# UNITED STATES PATENT AND TRADEMARK OFFICE

APPLICATION NO.	FILING DATE	FIRST NAMED INVENTOR	ATTORNEY DOCKET NO.	CONFIRMATION NO.
10/574,090	03/30/2007	Lino Dreyer	HWR-0183US	8930

<b>Office Action Summary</b>	<b>Application No.</b> 10/574,090	<b>Applicant(s)</b> DREYER ET AL.	
	<b>Examiner</b> Madison L. Wright	<b>Art Unit</b> 3781

## DETAILED ACTION

This figure, now referred to as annotated Fig. 1, used for the rejection of claims 1-14 has been replicated below, and the Examiner has added reference points for ease of explanation, and said reference points will be used for the rejection of claims 1-14 below.

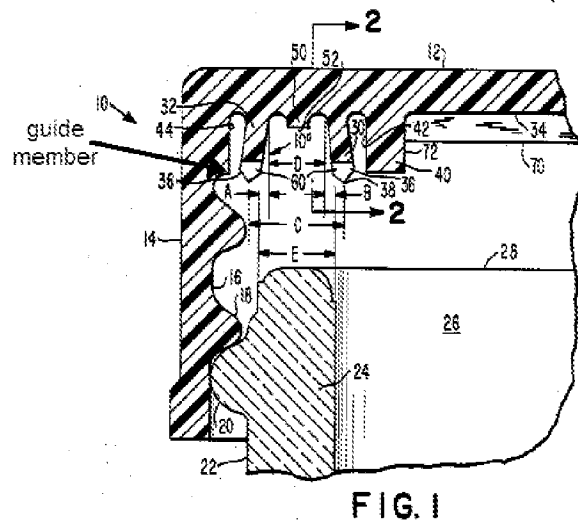
As to claim 1, Dutt teaches a plastics closure (closure cap 10) for a container, the closure comprising a top plate (top 12), a side skirt (side wall 14) depending from the periphery of the top plate (Fig. 1), a sealing strip (outer sealing flange 32) depending from the top plate, a sealing strip depending from the top plate and adapted to sealingly engage the side of a container neck finish (container neck 24), and an abutment member (outer seal flange abutment surface 44) including a projecting guide member (guide member, annotated Fig. 1) for guiding the sealing strip towards the neck finish as the closure is applied, so that the strength of the seal is increased, wherein the guide member contacts the sealing strip over a relatively small area so that the friction between the

sealing strip and the abutment member is minimized and wherein the sealing strip is inclined radially towards the neck finish for improving the sealing effect (Fig. 1).

As to claim 3, Dutt teaches a closure according to claim 1, wherein the surface of the free end (free end 36) of the sealing strip tapers sharply (Fig. 1).
